Weathertightness of an infill wall-column junction

- 1.1 The matter submitted for determination by the Authority is the weathertightness of the junction between an infill wall and a structural column.
- 1.2 The Authority takes the view that it is being asked to determine whether the junction as installed is such that the exterior wall complies with clause E2.3.2 of the building code (the First Schedule to the Building Regulations 1992).
- 1.3 In making its decision, the Authority has not considered whether the wall complies with any other provisions of the building code, and has not considered any part of the building other than the junction.

SubmissionFIG1.dwg 040303

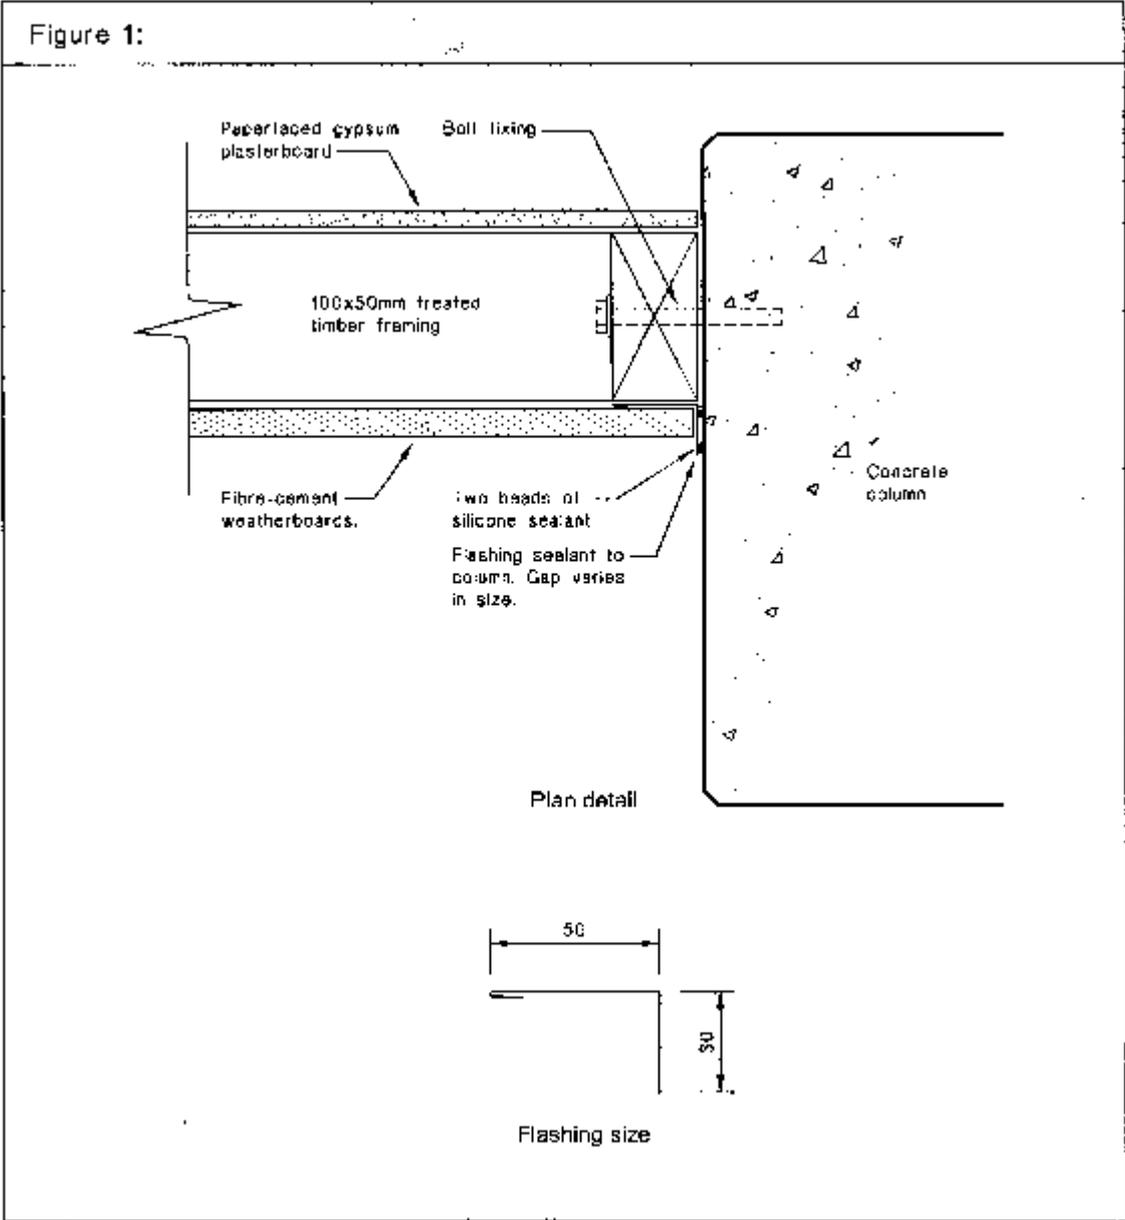
. . . I believe for a number of reasons that the flashing detail that has been installed will fail. I comment as follows:

The joint is reliant on a sealant to

- waterproof the junction to the flashing and concrete column
- act as a gap filler since the flashing is not in continuous contact with the column. . . .

There is no evidence of any second line of defence against the ingress of moisture . . .

Given that in general, the flow of water at vertical joints is much greater than the average flow of water over the wall, even if the flashing was well secured and waterproofed to the flashing/column junction water will get behind the ends of [the fibre-cement weatherboards]. The other concerns that I have [include]:

given the way in which the ends of [the fibre-cement weatherboards] have been fitted to or near the flashing, gives rise to "wicking" of moisture through the end and back of [the fibre-cement weatherboards]. Fibre cement as a material is prone to such a problem to a greater extent than many other cladding materials. . . .

6.2 The Authority notes that the junction does not comply with the manufacturer's data in respect of a filler rod, and that the exterior bead of sealant is exposed to sunlight and weather, contrary to paragraph 3.1.1 of E2/AS1.

- (a) Determines that the junction as installed does not comply with the building code, and
- (b) Confirms the applicant's decision to refuse to issue a code compliance certificate.
